Intersection ID: 28859	Main Street: WILDBROOK_DR	Cross Street: WREN_CREEK_DR	Location:	E
ADA ID: E38AC7278E44	Ramp Type: PerpDiag	Initial Pass/Fail: Fail	Overall Compliance: No	Severity Score: 8.75

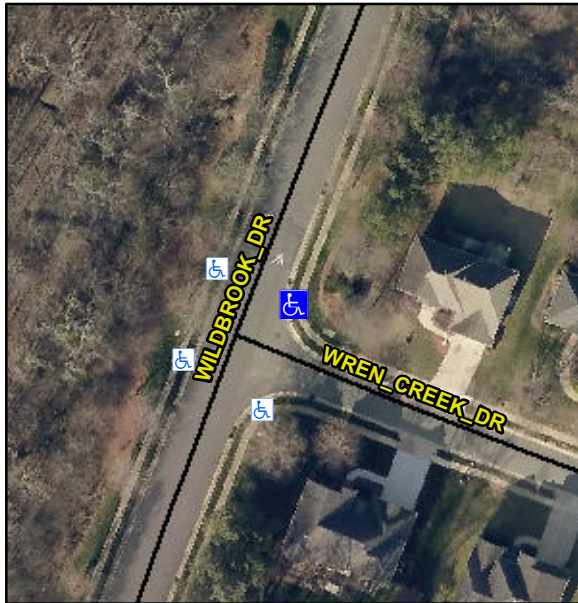
Compliance	Description	Data	Compliance	Description	Data
N/A	Ramp Length (in)	47.0	Yes	Ramp Slope (%)	6.5
No	Ramp Width (in)	42.0	Yes	Ramp XSlope (%)	1.2
N/A	Flare Type LT	N/A	N/A	Flare Type RT	N/A
N/A	Flare Slope LT (%)	N/A	N/A	Flare Slope RT (%)	N/A
N/A	Flare Traversable LT?	N/A	N/A	Flare Traversable RT?	N/A
N/A	Landing Length (in)	N/A	N/A	DWS Provided?	N/A
N/A	Landing Width (in)	N/A	N/A	DWS Contrast?	N/A
N/A	Landing Slope (%)	N/A	N/A	DWS Length (in)	N/A
N/A	Landing X Slope (%)	N/A	N/A	DWS Full Width?	N/A
N/A	Landing Curb? (Y/N)	N/A	N/A	DWS Offset (in)	N/A
N/A	Shared Landing?	N/A			
N/A	Gutter Ponding?	N/A	N/A	Gutter Slope (%)	N/A
N/A	Gutter Lip Ht (in)	N/A	N/A	Gutter X Slope (%)	N/A
N/A	Painted X Walk1?	No	N/A	Painted X Walk2?	No
	X Walk 1 Direction	To NW		X Walk 2 Direction	To SW
N/A	X Walk 1 Width (in)	N/A	N/A	X Walk 2 Width (in)	N/A
	X Walk 1 Slope (%)	4.3		X Walk 2 Slope (%)	1.5
	X Walk 1 X Slope (%)	1.9		X Walk 2 X Slope (%)	0.6

N/A	Ramp inside XWalk1?	N/A	N/A	Ramp inside XWalk2?	N/A
	Road Slope (%)	3.1	N/A	Clear Space?	N/A
	Road X Slope (%)	1.9	N/A	Clear Space to XWalk (in)	N/A
N/A	Any Obstructions?	N/A	N/A	Storm Grate/Utility Hazard?	N/A
	Obstruction Type			Storm Grate/Utility Type	
		N/A			N/A
			Yes	Surface Condition? (G/P)	Good

Remove & Replace Curb Ramp With Two New Directional Ramps or Equivalent.
